Our Ref: 40441

10 July 2025

PARCEL R11 OF PHASE 2B OF THE SOUTH WOKINGHAM STRATEGIC DEVELOPMENT LOCATION: RESERVED MATTERS APPLICATION (REF: 250678)

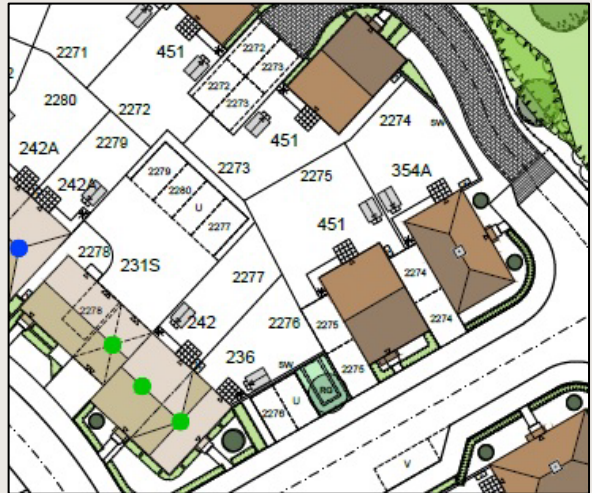
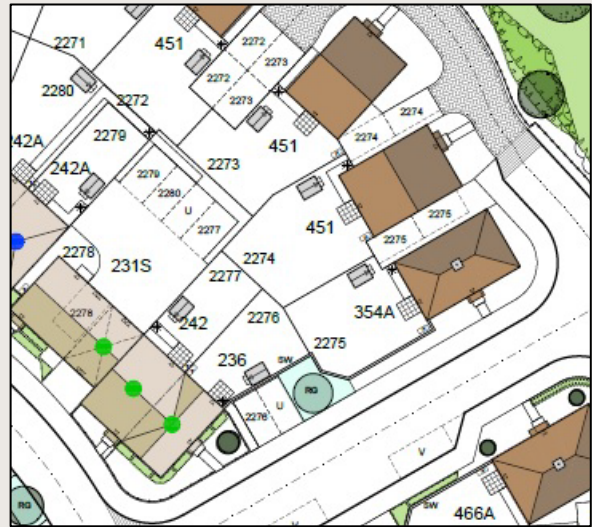
Ref	Issues Raised	Response
1	Designing Out Crime Officer (11th April 2025)	
1.1	<i>"There are 4 locations throughout the proposed development with undercroft access to a rear parking courtyards. The vehicular access into the parking court needs to be electronically gated with key fob access provided to associated dwellings. Any</i>	Condition 61 of the hybrid application (Ref: 191068) states that <i>"no gates or barriers shall be erected on any shared vehicular access"</i> . Therefore, in accordance with Condition 61, the accesses to the shared rear parking areas will not be gated. Notwithstanding this it should

Ref	Issues Raised	Response
	<i>additional pedestrian access into the space will also need to be gated."</i>	also be noted that the parking areas are overlooked by habitable rooms in the Flat Above Garage ('FOG').

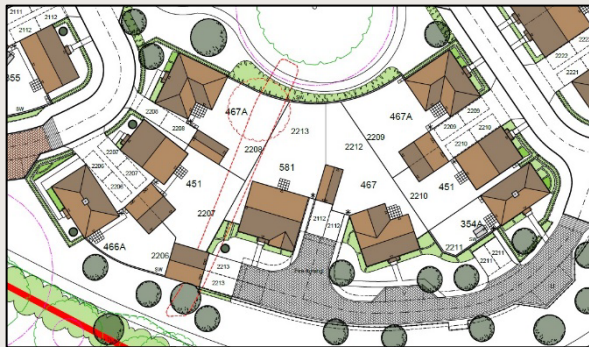
3.28	<i>"Recommendation: Railings to the front of plot 2108 are shown to follow the back of the footpath, therefore the proposed hedgerow will need to also follow the back of the railings rather than cut across the front of the garden. The Malus proposed for this plot should be replaced with a slightly larger tree on this corner."</i>	The hedgerow to the front of plot 2108 has been adjusted to follow the back of the railings rather than cutting across the garden. There is not the NHBC offset space to change the tree so an additional spec shrub has been added instead.
